RICHARDSON SUBDIVISION

APPLICATION NUMBER 1 DATE February 2, 2012
APPLICANT Richardson Subdivision
REQUEST Subdivision

DETAIL SITE PLAN

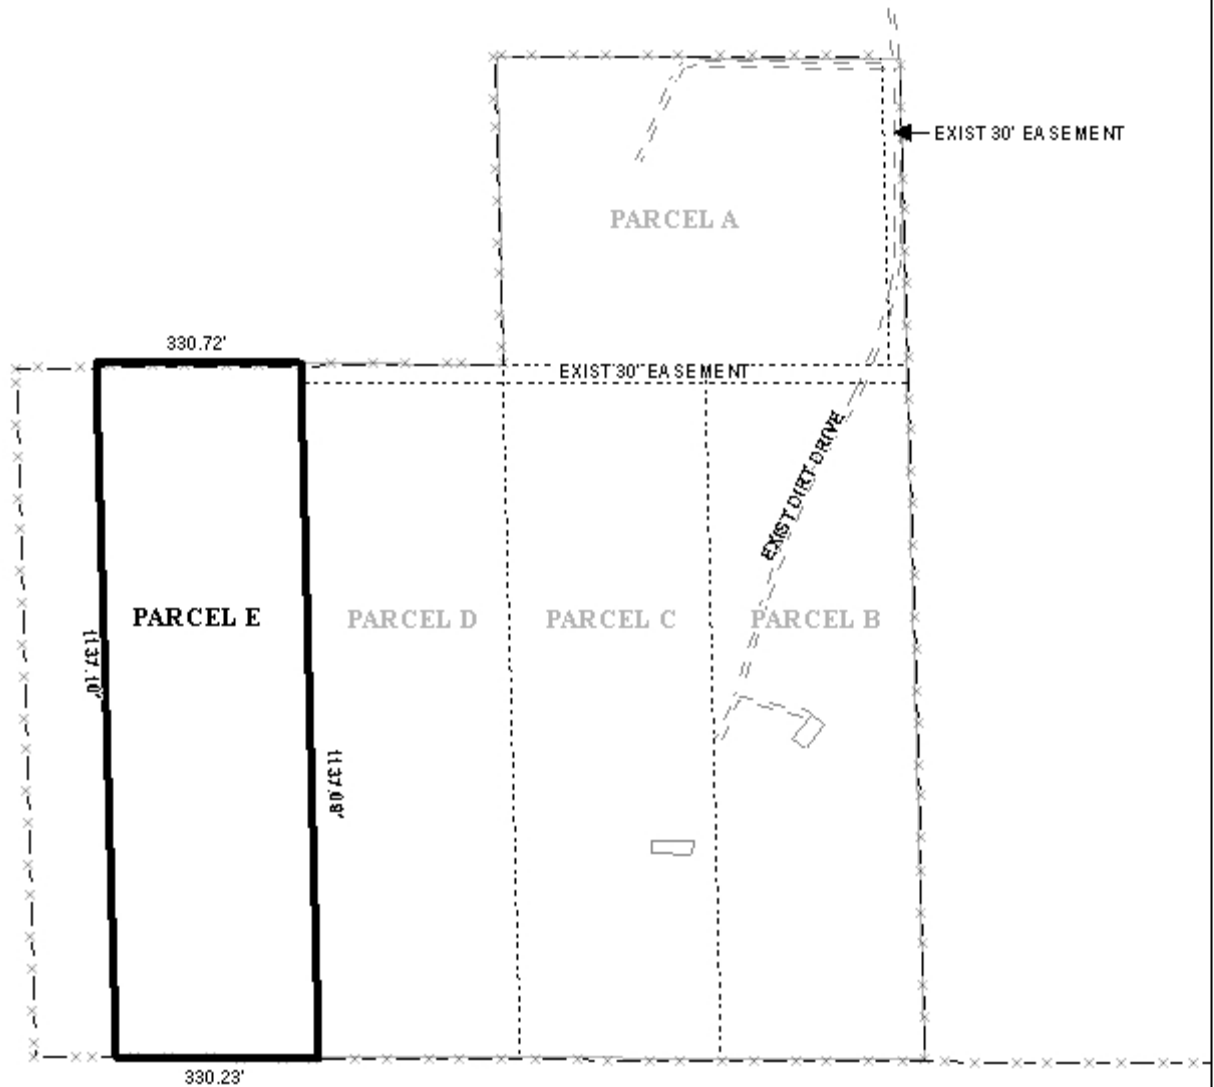
Section V.D.9. of the Subdivision Regulations requires the provision of a 25-foot minimum building setback from the “front property line,” which in this case, staff has determined to be where the recorded easement enters the site. Therefore the plat should be revised to show and label a 25-foot minimum building setback from the easement location.

The lot size information on the preliminary plat should be retained for the final plat.

- 3) Placement of a note on the final plat stating that there shall be no future subdivision of the lot until the private street is improved to meet the minimum standards of Section VIII. of the Subdivision Regulations;
- 4) Depiction and labeling of the 25-foot minimum building setback line from the depicted access easement;
- 5) Placement of a note on the plat stating that development of the site must be undertaken in compliance with all local, state and Federal regulations regarding endangered, threatened or otherwise protected species; and
- 6) Placement of a note on the plat stating that any lots which are developed commercially and adjoin residentially developed property must provide a buffer, in compliance with Section V.A.8. of the Subdivision Regulations.
